# SUNSET VILLAGE FILING NO. 4

## CONSTRUCTION PLANS

**CONSTRUCTION DRAWINGS AMENDMENT, DATED APRIL 4, 2026 BY ENGINEERING LOCAL XPERTS, LLC.**

CONSTRUCTION DRAWINGS  
POND 2

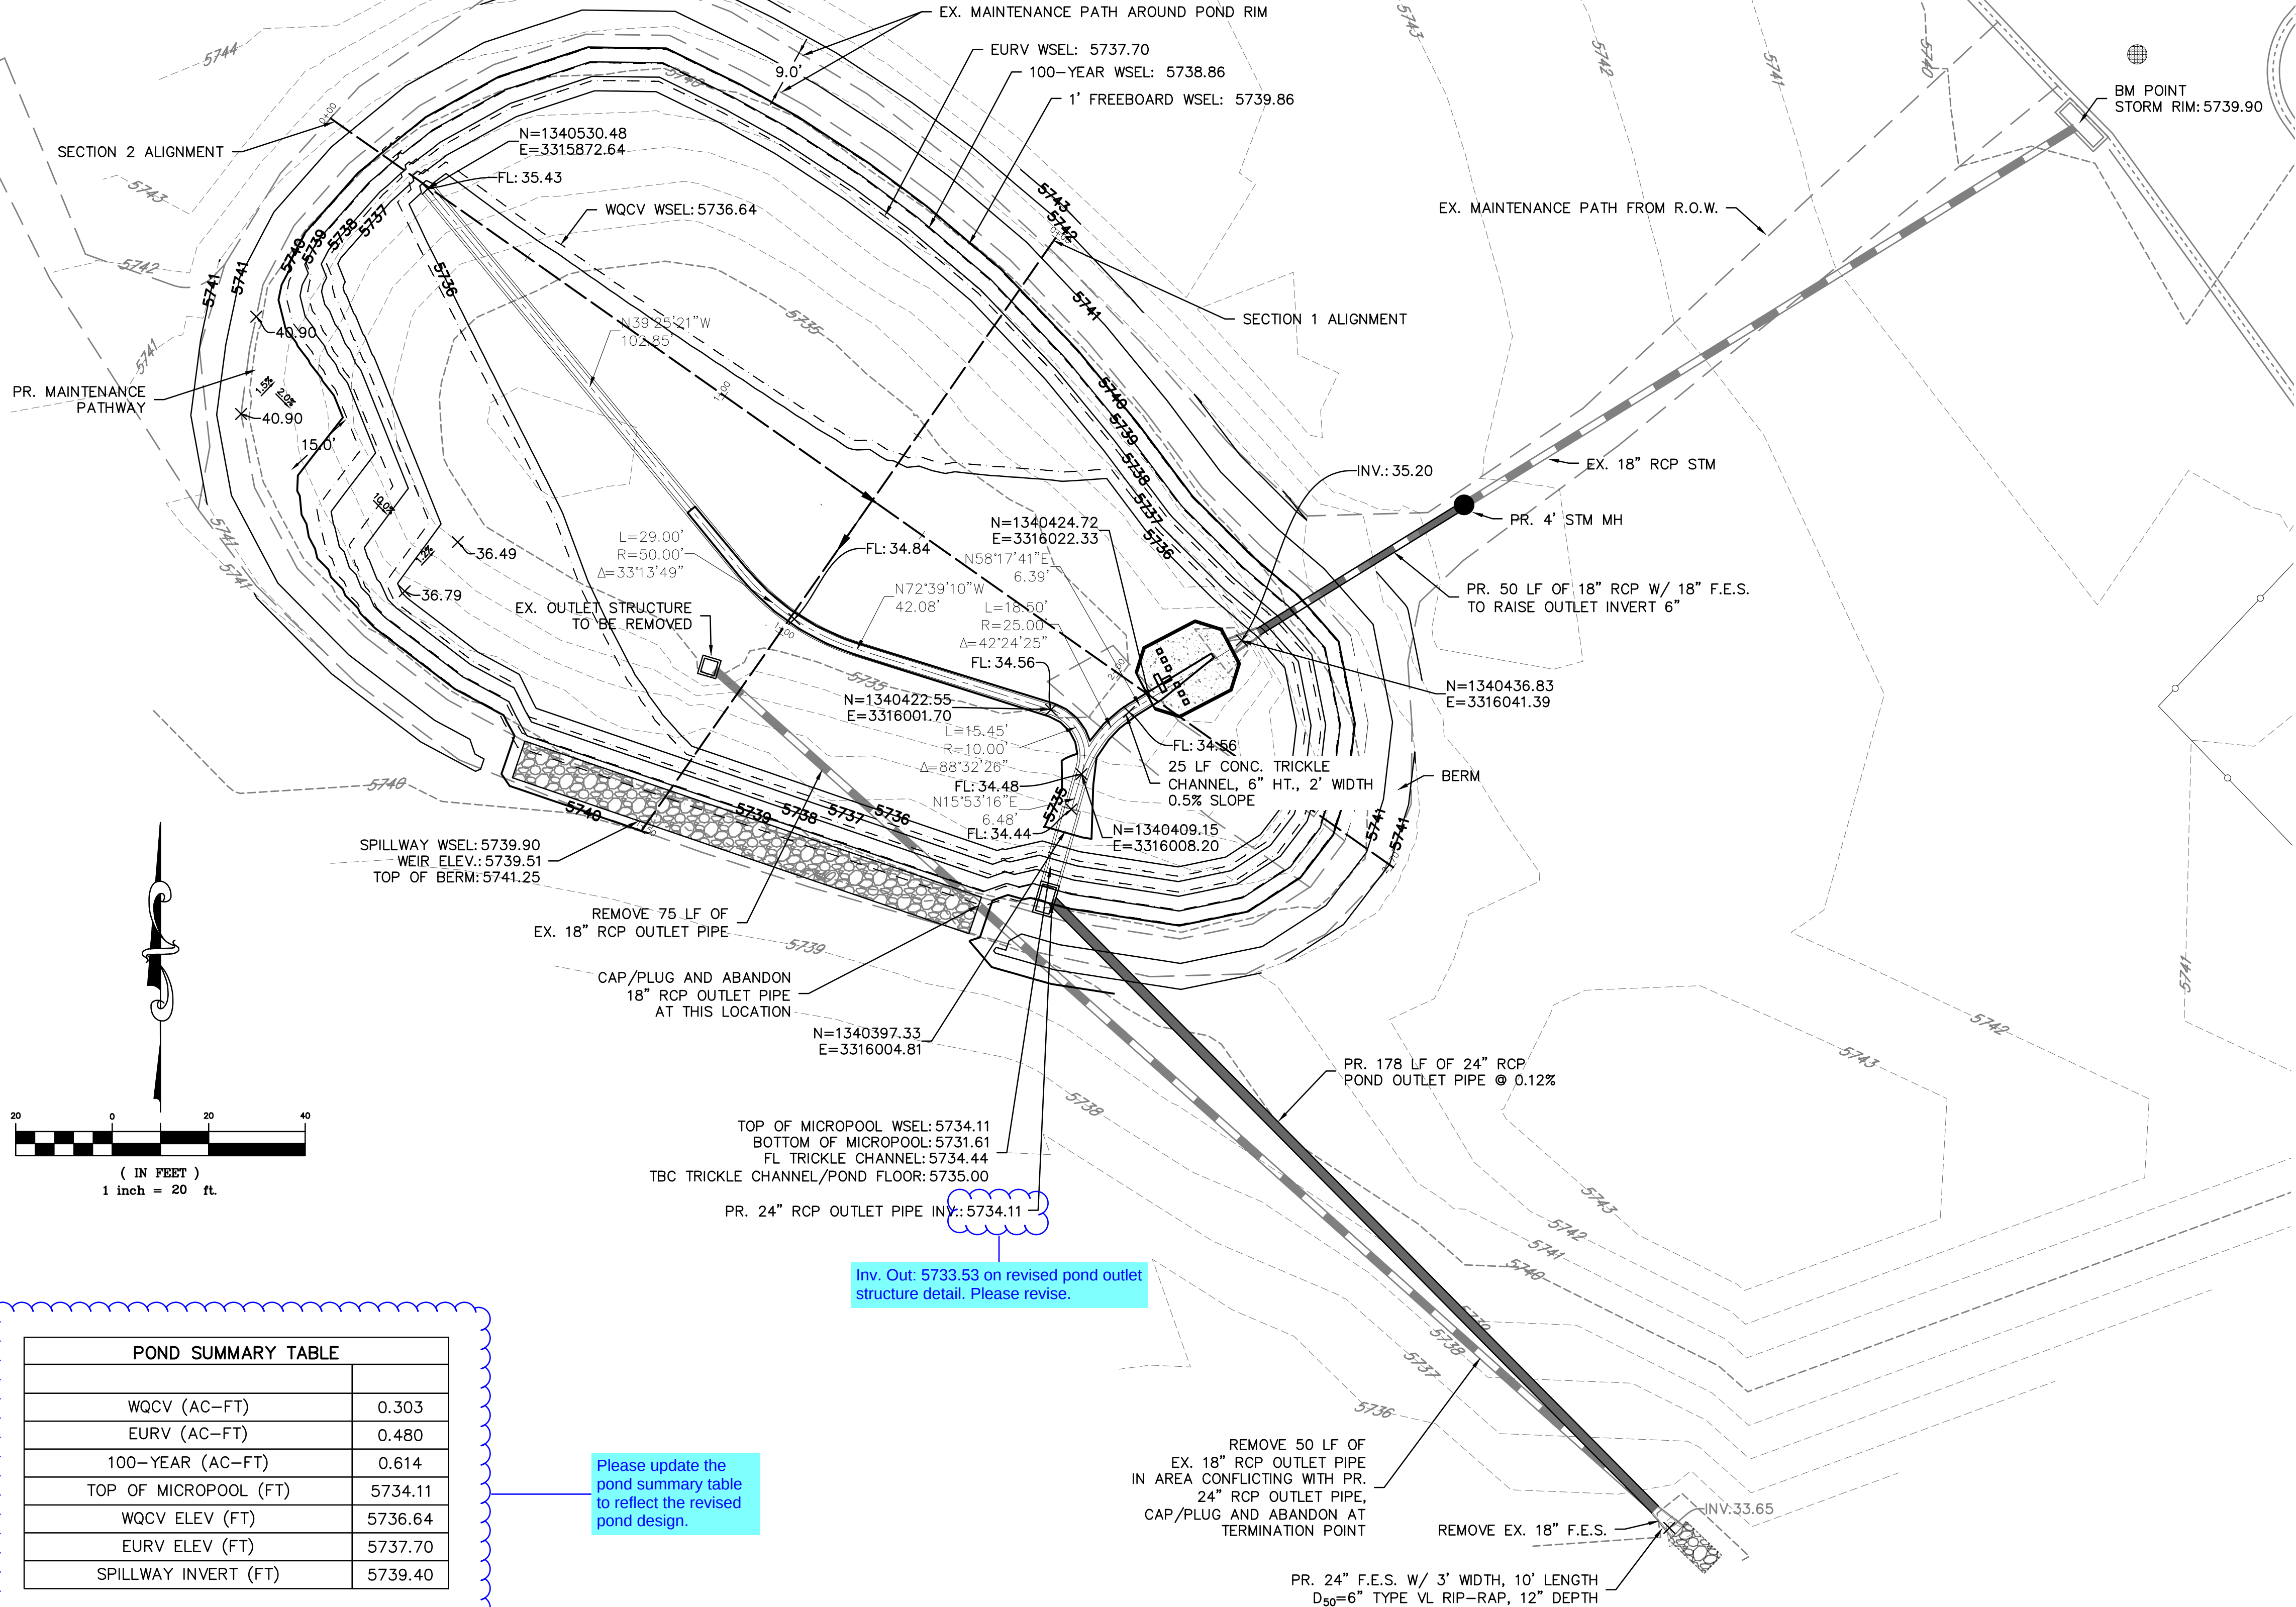
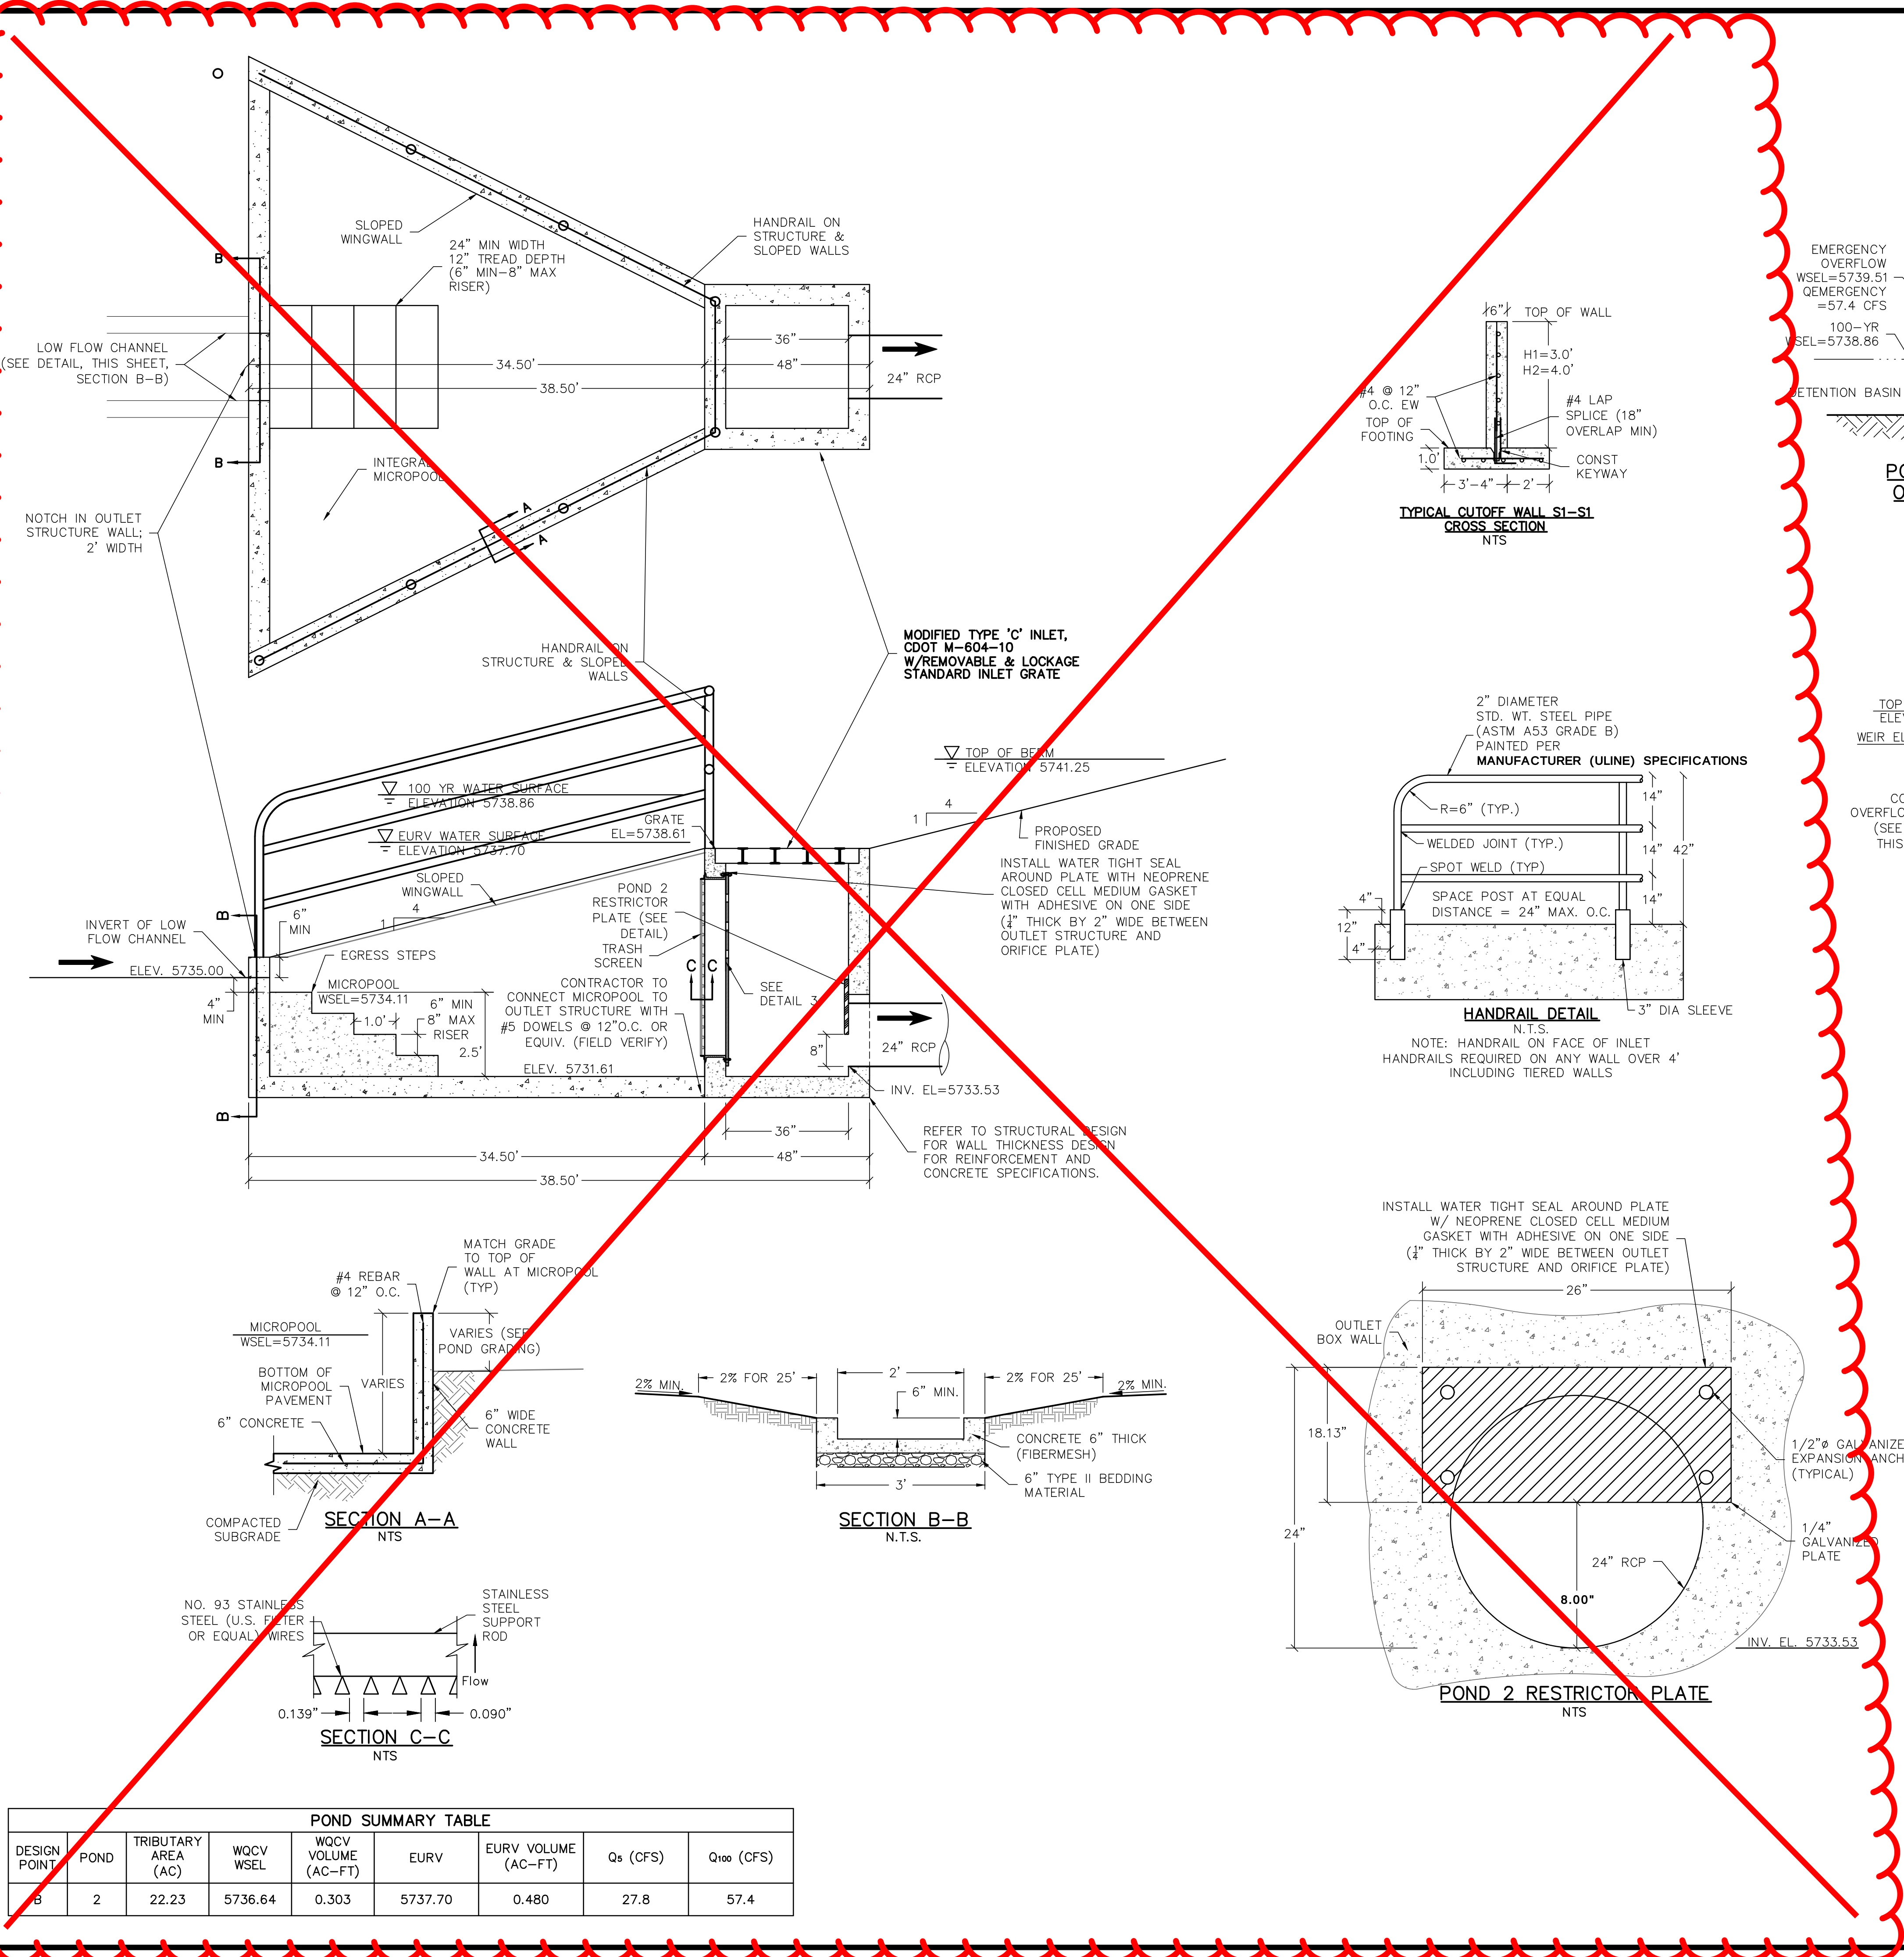
Please update the Pond 2 plan to be consistent with the revised pond outlet structure and forebay details shown on Sheets 20-22. Several elevations on the current Pond 2 sheet—including top of micropool, WQCV WSEL, EURV WSEL, and 100-year WSEL—do not match the updated design information.

Please update the pond summary table to reflect the revised pond design.
